THE CITY OF SAN DIEGO

REPORT TO THE PLANNING COMMISSION

REPORT NO. PC-13-060

COSTEBELLE RESIDENCE; PROJECT NO. 295796; PROCESS THREE

EAST ELEVATION BUILDING "B"

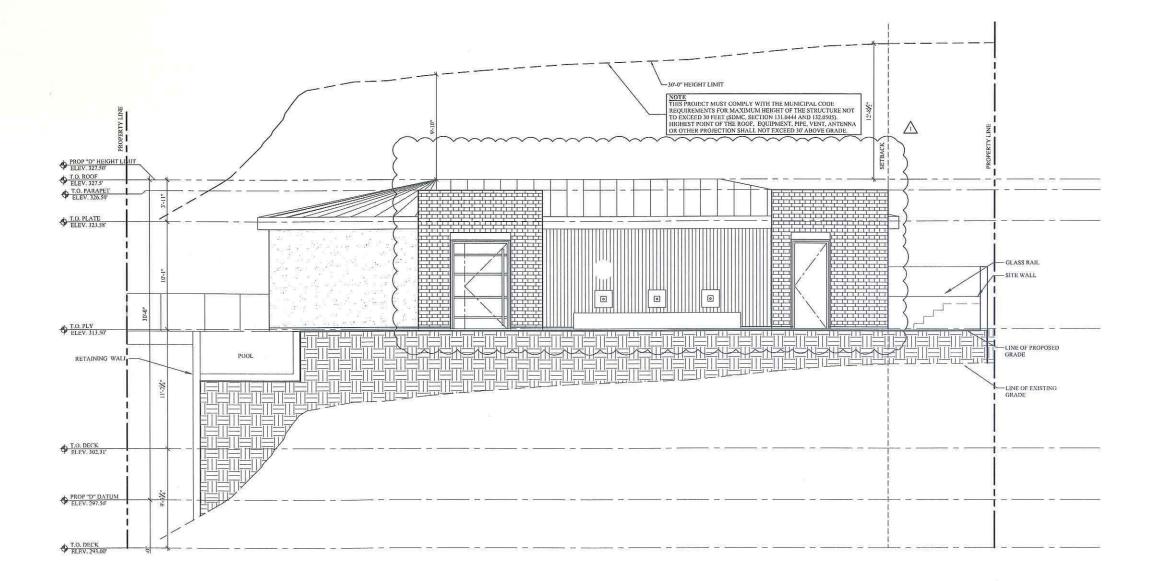
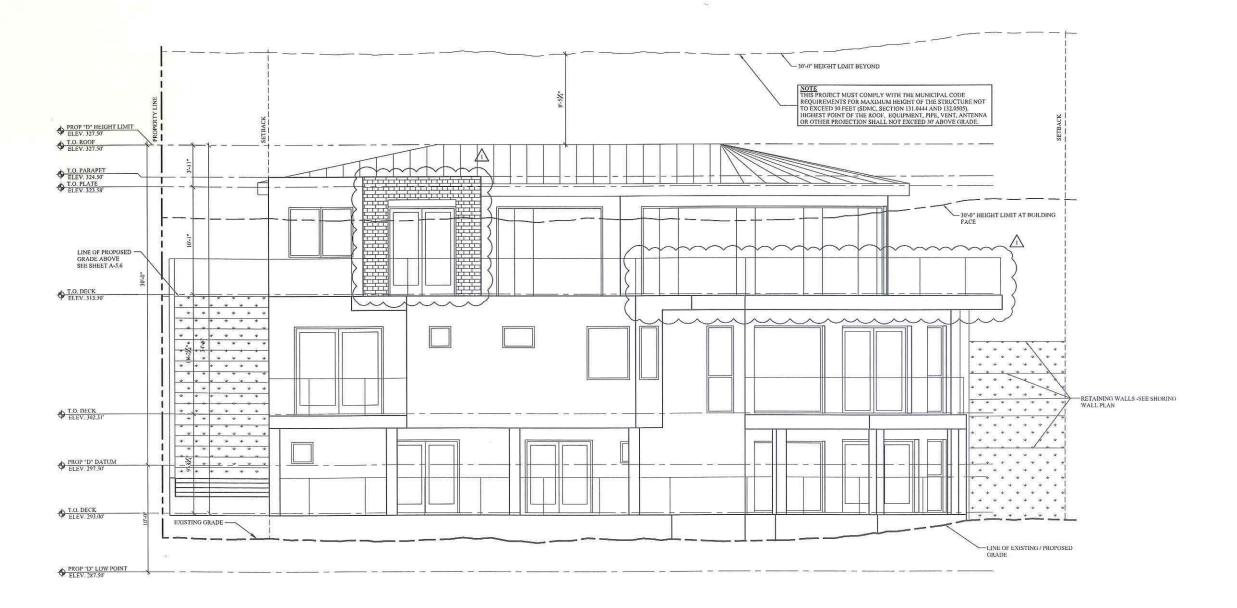
- a. The setback and relationship of the front wall of the proposed guest quarters to the front wall of the garage below presents an upper level front yard setback that is generally not in conformity with the upper level setbacks in the vicinity as is required by LDC Sec. 1510.0304(b).

- b. The garage with the proposed guest quarters above is so different in form and relationship to the street from that of other structures in the area that the proposed guest quarters addition is not in accordance with the General Design Regulations the La Jolla Shores PDO, LDC Sec. 1510.0301(b) and will disrupt the architectural unity of the area.

Response by Marengo Morton Architects; The code discusses stepping back at the second floors and articulating facades. Due to the fact that the site is very steep, we are close to the street within 5ft of the property line which is allowed by code. We are also controlled by the prop d height limit, and the 30ft height limit that restricts us into a buildable envelope of which we meet all of these criteria. Then our step back of the second floor, is a break of the plane and we achieve that.

Mr. Merten feels it isn't enough, but the floor does break the plane and achieves relief to the façade in the intent of the code. The code does not list a number because it is not intended to go a distance to achieve a break

The proposed facade includes the use of varied but complimentary building materials and finishes, providing visual interest and relief to reduce the perceived bulk and scale of the structure. While the project does not utilize an additional second floor setback, approximately 12 feet of the first and second floor façade has been offset half a foot from the remaining portion and incorporates an arbor element to break the plane and provide additional relief. The entry gates have been incorporated into the garage structure façade which allows the proposed second floor guest quarters to appear stepped back from the side property lines.

<u>Staff Response</u>: Staff concurs with the applicant's response. There are a wide variety of home designs and configurations in the area and as proposed guest quarters setback generally conforms with other properties in the vicinity.

Revised Plans with 3:12 Roof Pitch

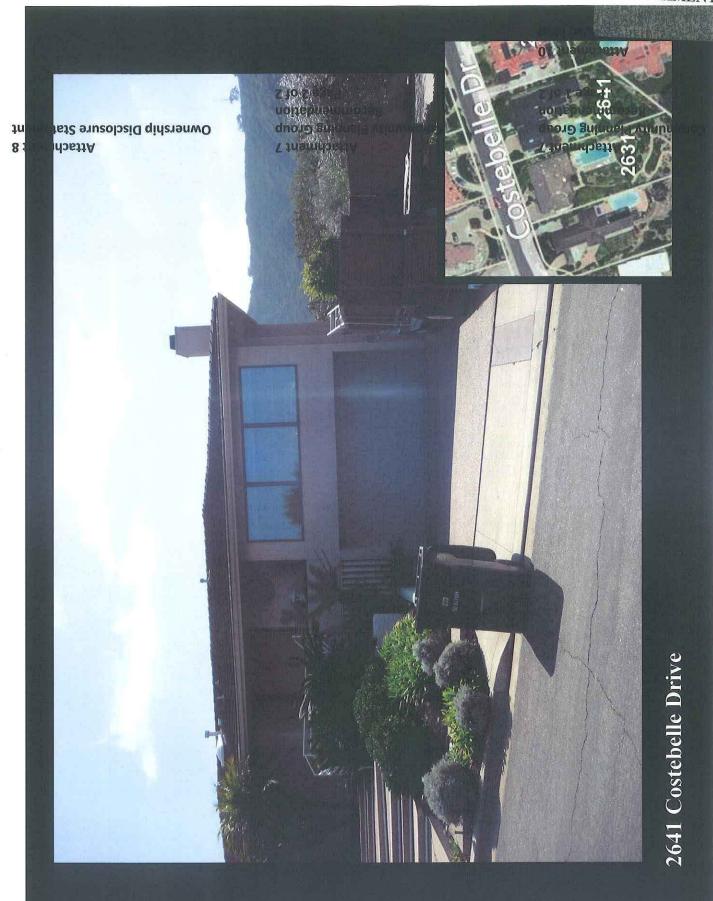
This recommendation of approval was based on the plans provided at the meeting by the applicant, which show a full 3:12 pitched roof for the proposed guest quarters. The applicant has incorporated a 3:12 pitched roof in order to meet the Municipal Code Section 141.0306, Separately Regulated Use Regulations, Guest Quarters or Habitable Accessory Buildings, height requirements. A copy of the revised plans is attached.
